工程指示 / 要求簡箋 ENGINEER INSTRUCTIONS(E.I.)

工程指示編號:	EI-5707	修改版本:	-
	概		
工程編號:	J 856	工程名稱:	天榮站
收件人:	Maggie Lor	發件人:	Lai Sik Hung
工程項目:	鋁窗膠條開模及做樣辦(因早前鋁窗膠條鬆動,所以需再開新模)	日期:	09/02/2023

內容: 鋁窗膠條開模及做樣辦(因早前鋁窗膠條鬆動,所以需再開新模)

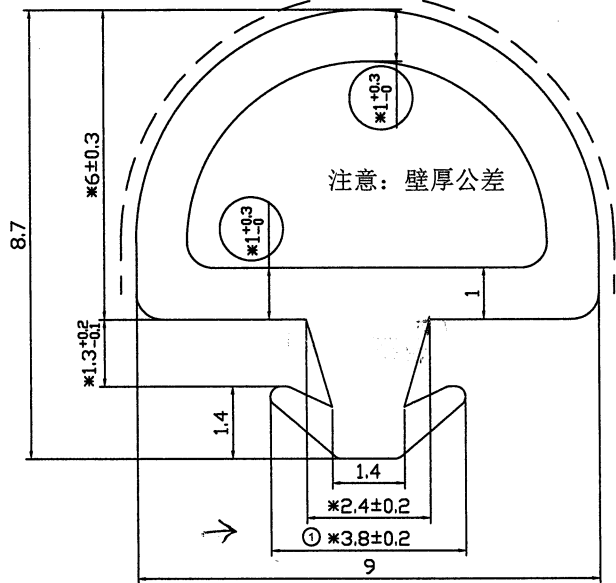
1. 未标注公差按IT14级执行;
2. 表面不得有扭曲、锯齿边、杂质颗粒及气泡等缺陷;
3. 带“*”尺寸为关键尺寸。
4. 带“——”面为见光面, 表面光洁度Ra=0.1. 根据客户图纸进行描图, 铝材槽口较小, 此胶条较难压进铝材, 请客户下单试装。
其余表面光洁度Ra=0.4。
5. 如无特殊要求, 则按我司《密封胶条激光打码技术规范》执行。

THE TABLE OF CHANGE RECORD				SIZE TOLERANCE		USER NO.	APPROVED & DATE
MARK	OLD-VER.	CONTENT	DESIGN	DATE	RANGE	TOLERANCE	
△	A	① 3.6±0.2 更改为 3.8±0.2	梁弘业	2023/02/07	0-1.5	±0.15	2091-856-WiH-S52A
△					1.5-2.5	±0.20	KIND NO.
△					2.5-4.0	±0.25	PROOFREADING & DATE
					4.0-6.3	±0.35	MOULD&RACK NO.
					6.3-10	±0.40	158D05
					10-16	±0.50	CHECKED & DATE
					16-25	±0.70	梁弘业 2023/02/07
					25-40	±0.80	MATERIAL
					40-63	±1.00	MVQ(Silicone)
					63-100	±1.30	DESIGN&DRAWN & DATE
					ABOVE 100	±1.50	000
							HARDNESS
							65±5
							Tracking & DATE
							苏志君 2022/10/21

開模完成後請生產100m樣辦到美特廠.
